# UNITED STATES PATENT AND TRADEMARK OFFICE

APPLICATION NO.	FILING DATE	FIRST NAMED INVENTOR	ATTORNEY DOCKET NO.	CONFIRMATION NO.
10/555,388	11/02/2005	Shun Takahashi	ITO-101-PCT	9485
77464 7590 02/26/2009				
IPUSA, P.L.L.C. 1054 31ST STREET, N.W. Suite 400 Washington, DC 20007				
EXAMINER				
VOLZ, ELIZABETH J				
ART UNIT		PAPER NUMBER		
3781				
NOTIFICATION DATE		DELIVERY MODE		
02/26/2009		ELECTRONIC

# Office Action Summary

**Figure 1 (Grau)**

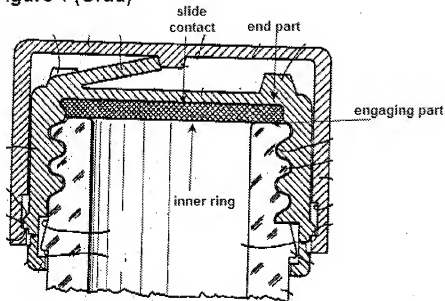
7. Regarding Claim 1, Grau discloses a safety container comprising a container main body 12 (Figure 1); an internal cap 14 (Figure 1) configured to be fit to an opening part of the container main body; and an external cap 18 (Figure 1) configured to be fit to the internal cap rotatably and moveably in upper and lower direction; wherein the external cap is not rotated with the internal cap in a case where only the external cap is rotated in an opening direction (Column 2, Lines 4-16); wherein the external cap is rotated in a state where the external cap is pressed toward an internal cap side so that the external cap and the internal cap are engaged and the internal cap is opened and separated from the container main body (Column 2, Lines 1-3); wherein the safety container further comprises an inner ring (Figure 1 below) having an end part (Figure 1 below) where an engaging part (Figure 1 below) is provided that engages a top part (Figure 1) of the opening part of the container main body both in a state where the internal cap is not separated from the container main body and a state where the internal cap is separated from the container main body and another end part where a slide contact part (Figure 1 below) is provided; and wherein the internal cap is rotated

with the external cap while the internal cap slides and contacts the slide contact part, by rotating the external cap in the opening direction in a state where the external cap is pressed toward the internal cap side until a rotation angle reaches a designated angle.
